## UNITED STATES PATENT AND TRADEMARK OFFICE

APPLICATION NO.	FILING DATE	FIRST NAMED INVENTOR	ATTORNEY DOCKET NO.	CONFIRMATION NO.
10/784,193	02/24/2004	Yoshiaki Okui	118827	1085
25944	7590	07/09/2008	EXAMINER	
OLIFF & BERRIDGE, PLC P.O. BOX 320850 ALEXANDRIA, VA 22320-4850			BERHANU, SAMUEL	
ART UNIT	PAPER NUMBER			
	2838			
MAIL DATE	DELIVERY MODE			
07/09/2008	PAPER

<b>Office Action Summary</b>	<b>Application No.</b> 10/784,193	<b>Applicant(s)</b> OKUI, YOSHIAKI
	<b>Examiner</b> SAMUEL BERHANU	<b>Art Unit</b> 2838

## DETAILED ACTION

**FIG. 1**  
**Prior Art**

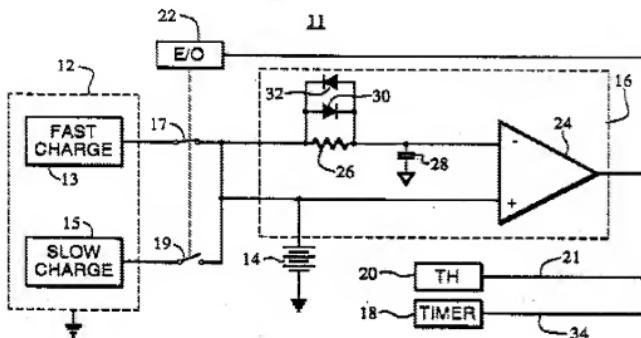
As to Claim 14, Young discloses in Figure 1, wherein said converter is a rectifier and said load includes a direct-alternating current inverter and a load apparatus.

As to Claim 15, Yong discloses in Figure 1, wherein said converter is a rectifier, the uninterruptible power supply device further comprising a direct-alternating current inverter connected midway between the storage battery and the load  
(With regard to the particular location of the inverter, i.e., midway between the storage battery and the load, absent any criticality, is only considered to be a obvious modification as the courts held that there would be no invention in shifting the location of a structure of a device to another location if the operation of the device would not thereby be modified. In re Japikse, 181 F.2d 1019, 86 USPQ 70 (CCPA 1950)  
MPEP2144.04)

As to Claim 16, Yong discloses in Figure 1, wherein said converter comprises a mutual transducer of direct and alternating current, which connects to the power source in parallel with the load, and which connects the storage battery thereto.

As to Claim 17, Yong discloses in Figure 1, wherein said converter comprises a transducer of alternating and direct current which connects to the power source in parallel with the load, and which connects the storage battery and a direct-alternating current inverter.
